Access Compliance Report

Public Rights-of-Way

Intersection ID: 46787	Main Street: STOWE_ACRES_DR	Cross Street: MALLARD_WOODS_PL	Location: SW
ADA ID: 9247E6F60125	Ramp Type: PerpDiag	Initial Pass/Fail: Fail	Overall Compliance: No
Severity Score: 21.25			
Codes/Mitigation Info/Possible Solution		Field Measurements/Component Compliance

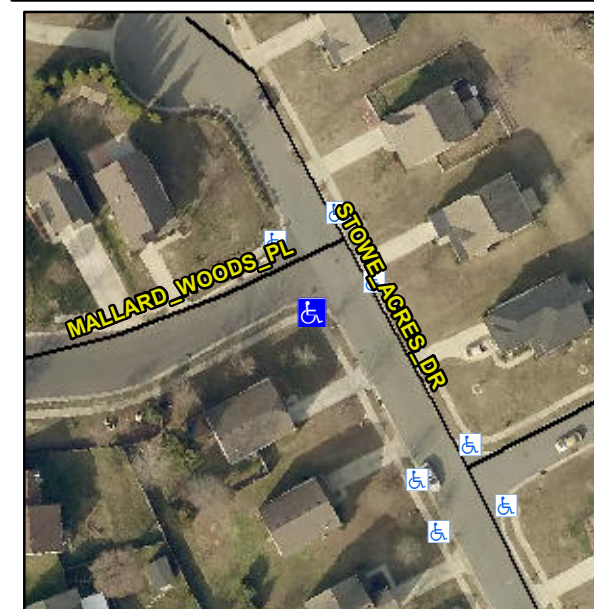
Not Found, R304.5.1, R304.5.3

Compliance	Description	Data	Compliance	Description	Data
N/A	Ramp Length (in)	49.0	Yes	Ramp Slope (%)	6.2
No	Ramp Width (in)	38.0	No	Ramp XSlope (%)	5.1
N/A	Flare Type LT	N/A	N/A	Flare Type RT	N/A
N/A	Flare Slope LT (%)	N/A	N/A	Flare Slope RT (%)	N/A
N/A	Flare Traversable LT?	N/A	N/A	Flare Traversable RT?	N/A
N/A	Landing Length (in)	N/A	N/A	DWS Provided?	N/A
N/A	Landing Width (in)	N/A	N/A	DWS Contrast?	N/A
N/A	Landing Slope (%)	N/A	N/A	DWS Length (in)	N/A
N/A	Landing X Slope (%)	N/A	N/A	DWS Full Width?	N/A
N/A	Landing Curb? (Y/N)	N/A	N/A	DWS Offset (in)	N/A
N/A	Shared Landing?	N/A			
N/A	Gutter Ponding?	N/A	N/A	Gutter Slope (%)	N/A
N/A	Gutter Lip Ht (in)	N/A	N/A	Gutter X Slope (%)	N/A
N/A	Painted X Walk1?	No	N/A	Painted X Walk2?	No
	X Walk 1 Direction	To E		X Walk 2 Direction	To N
N/A	X Walk 1 Width (in)	N/A	N/A	X Walk 2 Width (in)	N/A
	X Walk 1 Slope (%)	1.1		X Walk 2 Slope (%)	7.4
	X Walk 1 X Slope (%)	5.0		X Walk 2 X Slope (%)	1.6

Remove & Replace Curb Ramp With Two New Directional Ramps or Equivalent.
